Date: February 2, 2021

Subject: **Ventilation Screening**
Dr. Charles T. Lunsford School No. 19 Rochester, NY
465 Seward Street, Rochester, NY 14608

Linear slot diffuser located in Cluster Room 328. Typical of many classrooms visited.

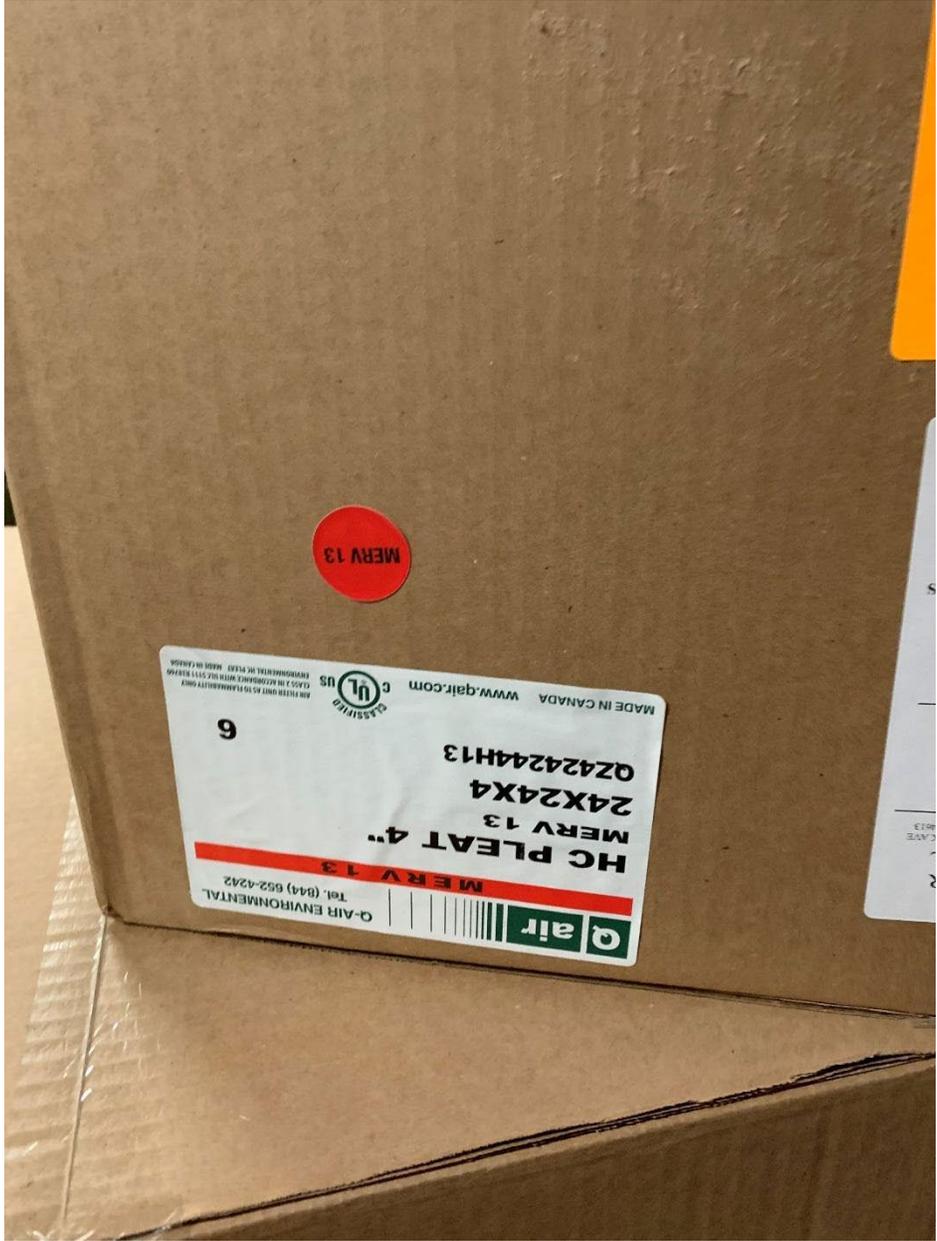
Outside air plenum in an air handler unit. The outside air dampers is minimally open due to temperature constraints.
